Point-by-point reply, manuscript hess-2020-468

Editor Decision: Publish subject to revisions (further review by editor and referees)

The authors analyze the impact of the spatial variability of rainfall and of the spatial arrangement of NBS on hydrological outputs of NBS scenarios at the urban catchment scale.

Figure 5. Two scenarios for each of NBS implementation, including porous pavement (PP1, PP2), rain garden (RG1, RG2), green roof (GR1, GR2), Combined1 and Combined2. The rectangular area presented in the PP1 scenario is the example area for applying fractal analysis.

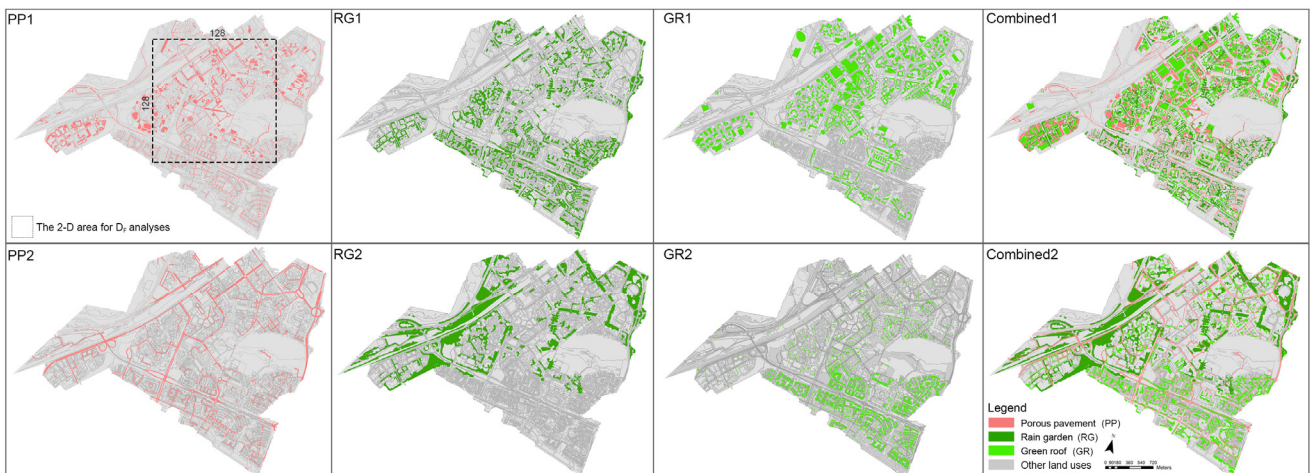
2. Figure 5, In the legend it should include an abbreviation of each NBS measures e.g., Porous pavement (PP), Rain garden (RG),...

Thanks to the referee's suggestion, we have revised the Figure 5 (in the revised manuscript is Figure 6) including the abbreviation of each NBS measures.

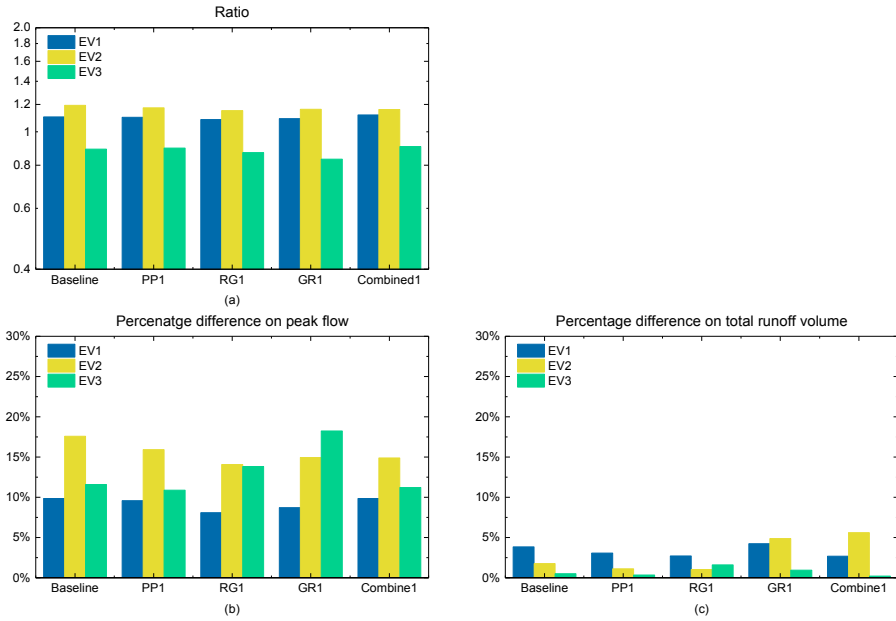
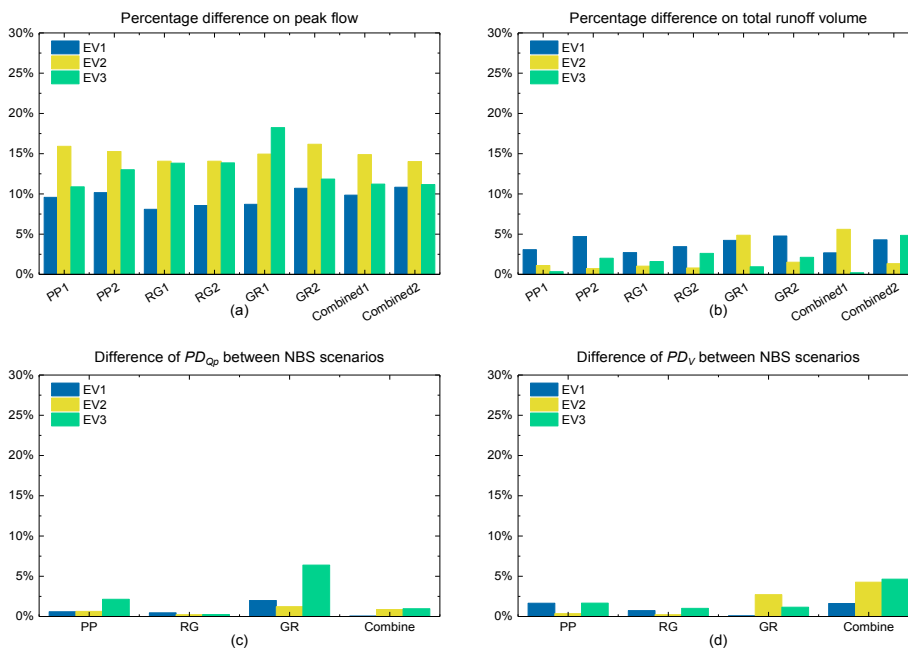
4. For Figure 12 and 16, can you discuss more on why percentage errors of peak flow are much higher than total runoff volume.

Thanks to the referee's suggestion. The authors added the discussions for Figures 12 and 16 (in revised manuscript is Figures 13 and 17) to enhance the comprehension and readability of the manuscript (in our revised manuscript, the verification metrics of percentage error was changed to percentage difference as the metrics throughout the manuscript. The corresponding abbreviation for percentage difference on peak flow was modified to ' PD_{Qp} ', and the percentage difference on total runoff volume was modified to ' PD_V ').

As shown in Figure 12 and Figure 16, the percentage difference on peak flow is much higher than that of the total

runoff for each scenario. These results can be explained by the fact that the spatial variability of rainfall intensity at the largest rainfall peak is strong in all three rainfall events, while the total rainfall volume for the gridded and uniform rainfall inputs is the same. This small PD_V is influenced by the differences on the grid scale (storage capacity, infiltration, etc.), which are differently modelled when the input is uniform or non-uniform. For these three rainfall events, the spatial variability of total rainfall depth is less pronounced with respect to the spatial variability of the rainfall intensity at the largest rainfall peak, and also there is no highly localized storm cell. Figure 3 (top) displays the rainfall intensity at the largest rainfall peak (per radar pixel) over the Guyancourt catchment area for the three studied rainfall events. It is noticed that the highest rainfall peak of the distributed rainfall is very variable in space, which enlarged the discrepancy with the corresponding uniform rainfall, resulting in a significant impact on the peak flow of each NBS scenario that simulated with two different rainfall inputs. However, the cumulative rainfall of the distributed rainfall input is not very variable in space (see Figure 3 middle). For instance, the standard deviation (SD) of the cumulative rainfall of the three rainfall events is around 1 mm, which indicates that the spatial variability of the distributed rainfall is not very pronounced at most of the time steps. Thus, the difference between distributed rainfall and uniform rainfall is relatively small during the whole rainfall period. Finally, the simulated flow of NBS scenarios under two different rainfall inputs is similar in most time steps, resulting in the percentage difference on the total runoff volume of NBS scenarios (simulated by distributed rainfall and uniform rainfall) is not significant.

Figure 18. Simulated flow ($\text{m}^3 \text{s}^{-1}$) of GR1 and GR2 scenario under the four syntactic rainfall events.

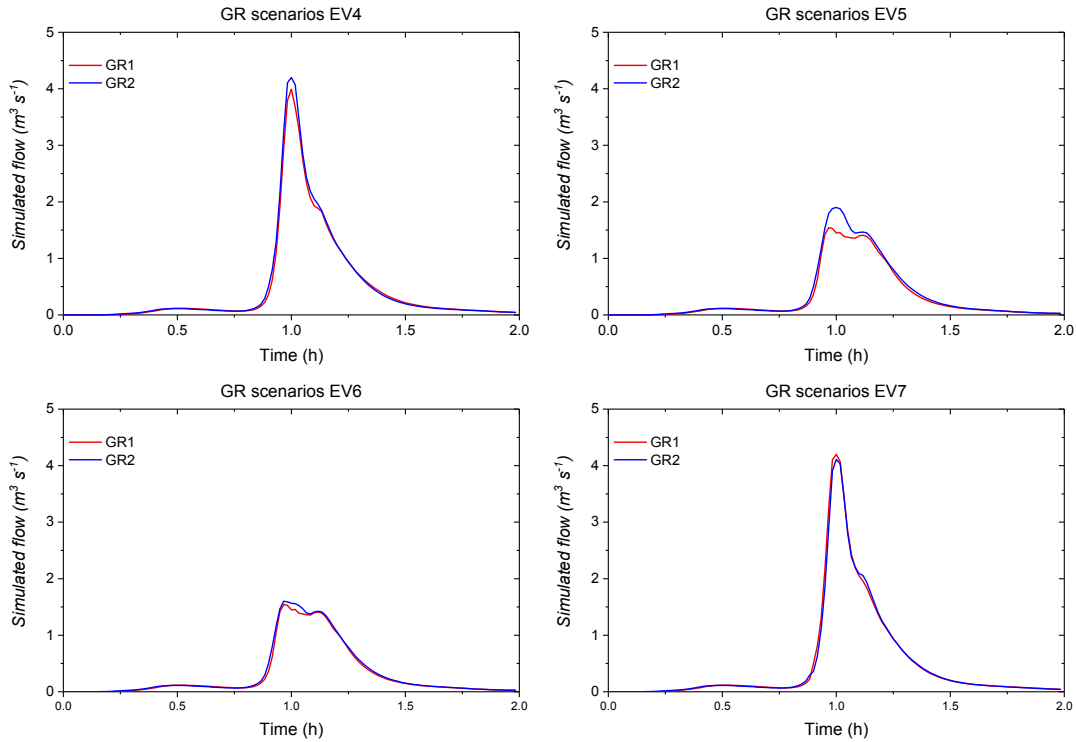
I think the authors chose for an elegant application by using the multifractal approach. The authors write: “For instance, both ‘hot spots’ (extremes) of the rainfall and NBS are scarce and therefore could rarely coincide, i.e., rainfall spikes may fall more often elsewhere than on NBS. Similar questions can occur for less extreme events. The effective NBS performance could be therefore biased with respect to their potential performance due to this problem of intersection between rainfall intensity and NBS”. This make me wonder if a synthetic experiment would have worked too. In such an experiment, you can exactly define where, how much and when the rainfall falls and the same for the location and density of the NBS applications. This would make it possible to do a larger sample analysis of the effects (the authors point on the need for this in the conclusion). Could the authors comment on this and if they agree that something like that – or another approach – is possible, write something about it in the discussion?

Thanks to the referee’s suggestion, we designed a synthetic experiment with the help of four synthetic rainfall events (EV4-EV7) and GR scenarios (GR1 and GR2). We added the description of the synthetic experiment and the corresponding results and discussions in our revised manuscript.

As shown in the hydrographs (Figure 18), the peak flow of GR1 scenario was expected to be less than that of GR2, and this is confirmed for EV4, EV5, and EV6. For EV4 and EV5, with the same maximum intensity of 55 mm h^{-1} , the hydrographs of these two events significantly differ, with the peak flow decreasing by a factor 2 for EV5. However, the only difference in the rainfall inputs is that there is zero rainfall outside of the GRs during the 3 min rainfall peak. The percentage difference on peak flow (PD_{Op}) and total runoff volume (PD_V) of GR1 and GR2 scenario under the EV4 is around 5 %, and 4.3 %, respectively (see Figure 19). For EV5, the PD_{Op} and PD_V increase to 20.7 % and 7.8 %, respectively. This confirms that without the impact of runoff that generated by other land uses, the intersection effects increase considerably with the high rainfall intensity, also increasing the NBS effectiveness. For the EV6, the maximum rainfall intensity during the 3 min has been decreased to 17 mm h^{-1} . This was sufficient to further reduce

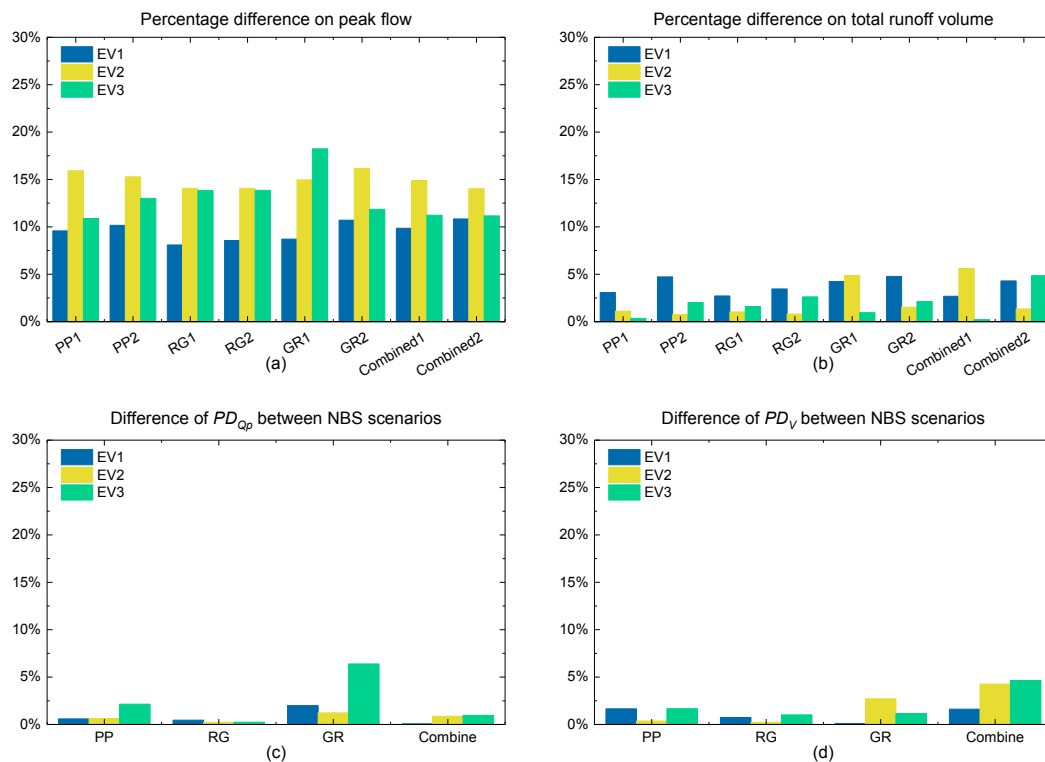
Page 14, lines 433 – 437: I think this is one of the most interesting (and important) results of the study. However, it is not very easy for the reader to make the comparison based on the figures (e.g. figures 14 and 16). Could the authors add a subplot to figure16 indicating the differences between the two scenarios (so the difference between uniform and non-uniform rainfall plus the difference between the scenarios) and tell somewhat more about it?

The resulting uncertainty on the peak flow and total runoff volume (PD_{Op} and PD_V) of the third set of modelling experiments are shown in Figure 16. Firstly, we found that the spatial variability of rainfall has a certain extent impact on the peak flow of each scenario, with the PD_{Op} ranging from about 8 % to 18 %. With the exception of GR1, all the NBS scenarios have a similar tendency: the PD_{Op} are the lowest for the first event, and the highest for the second one. Namely, for most of NBS scenarios, the PD_{Op} (uncertainty on peak flow) increases with the increase of the spatial variability of rainfall intensity. As shown in Figure 16c, comparing the PD_{Op} between scenarios of PP1 and PP2, RG1 and RG2, as well as Combined1 and Combined2 for the three rainfall events, the maximum difference is less than 3 %. However, comparing the PD_{Op} between GR1 and GR2, the difference is larger, especially in EV3 (> 6 %). For the GR1 scenario, PD_{Op} range from about 8.7 % to 18 % in all three rainfall events, and those of GR2 range from about 10.7 % to 16 %. Furthermore, for GR1, the largest PD_{Op} is in EV3, but for GR2, the largest PD_{Op} is computed for EV2. The difference of PD_{Op} between GR1 and GR2 scenarios demonstrated that the spatial variability of rainfall and the spatial arrangement of GR measures have some intersection effects on the peak flow of GR scenarios. However, it is not evident for the other NBS scenarios. One of the reasons has been discussed in Sect. 4.1.2: in the GR1 scenario, GR measures are mainly implemented in the north part of the catchment, which coincidentally received lower rainfall (distributed EV3); namely, the "hot spots" of the rainfall field were highly intersected by the GR measures due to their high fractal dimension. Therefore, the peak flow was effectively reduced by the GRs. On the contrary, for GR2 scenario, the GR measures are mainly located on the south side of the catchment, which scarcely intersected with the rainfall spikes. Thus, comparing with the GR1 scenario, the difference of GR2 scenario simulated under the distributed rainfall and uniform rainfall is less significant. Another possible reason is GR has the lowest storage capacity in the studied NBS, as well as the studied rainfall events are not intense enough to saturate the other types of NBS (see Versini et al., 2016 for a comparison of different properties of GR). Her et al. (2017) also indicated the hydrological performances of NBS are sensitive to their configurations. However, the most plausible reason is that the intersection effect is more perceptible for GRs, as they only respond to local precipitation, while it is often masked for other NBS measures that must also mitigate runoff received from other parts of the watershed. Indeed, the already mentioned integrative character of runoff should reduce the evidence for intersection effects in other NBS scenarios, whether for gridded or uniform rainfall.

As referee suggested, we add a subplot to Figure 16 (in the revised manuscript is Figure 17). The corresponding figures and discussions can be found in the answer for **2.5 The results in a larger perspective**.

Figure 2: Left: land use map (baseline scenario); right: drainage system with four conduits (4541, 4542, 4543, and 4544) highlighted.

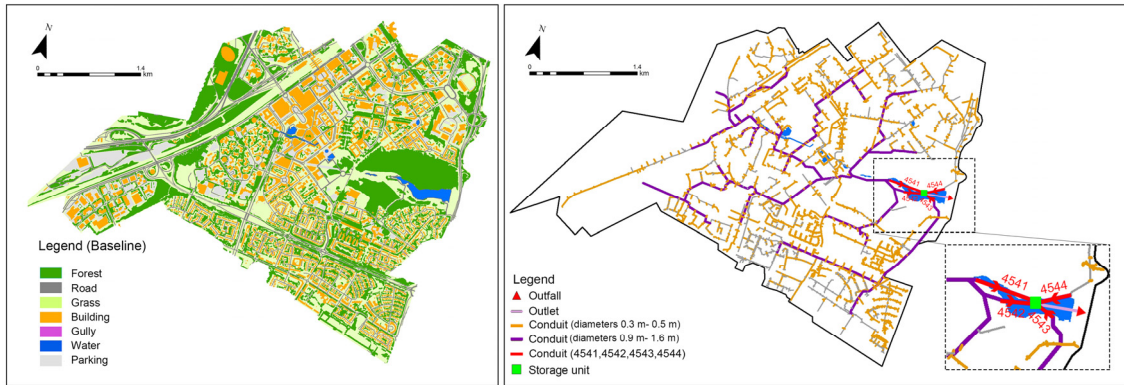
Figure 2: I may be wrong, but it seems that the legend colour for forest is not exactly the same as the colour used in the map. Figure 3: The rainbow colour map is not always intuitive, also here with respect to the rainfall amounts. I recommend using a more intuitive colour map. Some explanations and inspiration can be found in Crameri et al. (2020).

Thanks to your suggestion and reference. The legend colour for the forest was changed in the map (Figure 2). The rainbow colour map was changed for Figure 3

Figure 10: Simulated flow ($\text{m}^3 \text{s}^{-1}$) of the baseline scenario under three distributed rainfall events and three uniform rainfall events: (a) EV1, (b) EV2, (c) EV3.

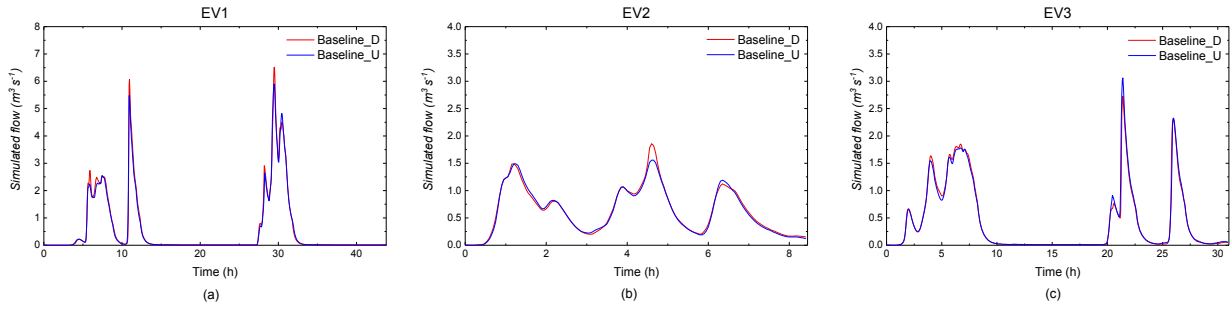
Figure 10: The authors refer in the caption to (a) EV1, (b) EV2, (c) EV3, but the letters (a) – (c) are not shown in the figure.

Thanks to your suggestion. The letters (a) – (c) were added in the revised figure (in the revised manuscript is Figure. 11).

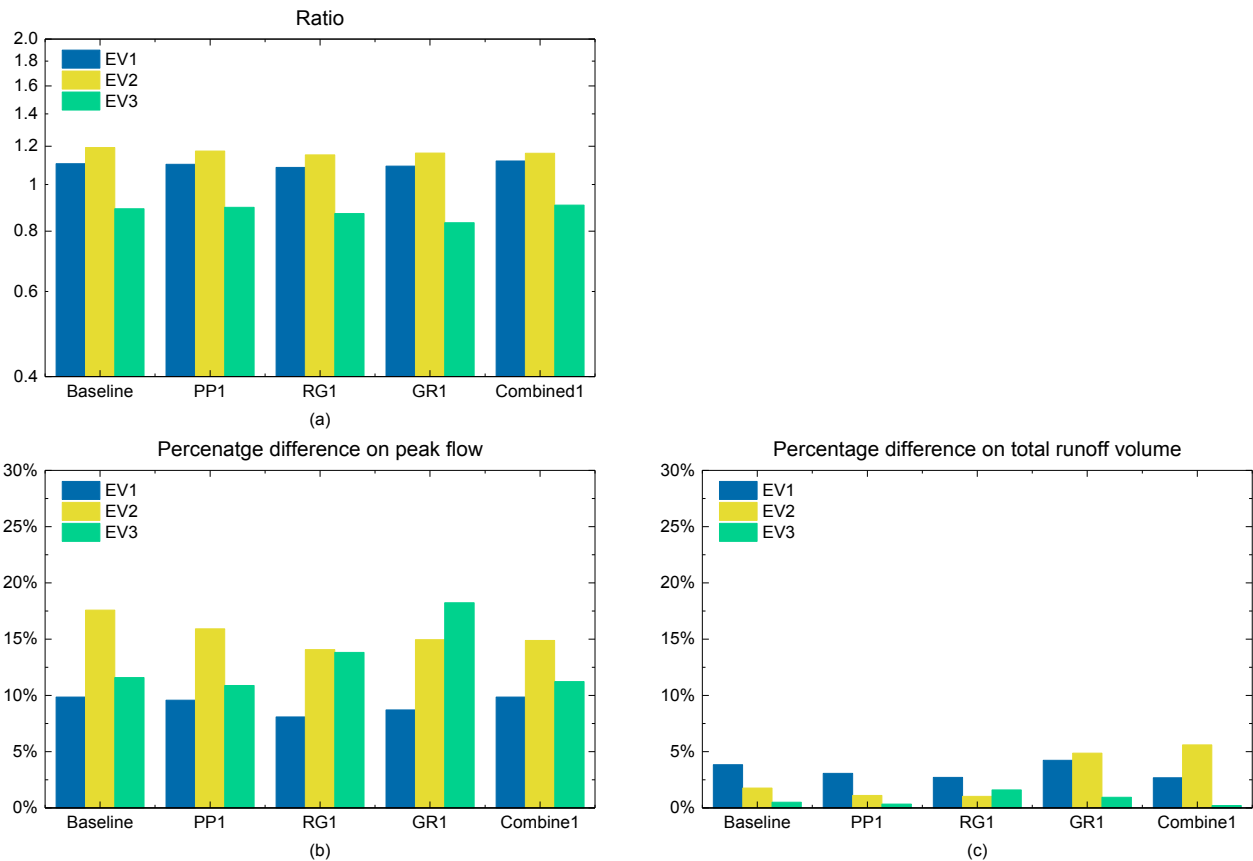
Figure 12c: It would be better to show the ratio on a logarithmic axis.

Thanks to your suggestion. The ratio of peak flow between the scenarios under the distributed rainfall and the scenarios under the uniform rainfall was plotted on a logarithmic axis in the revised manuscript.
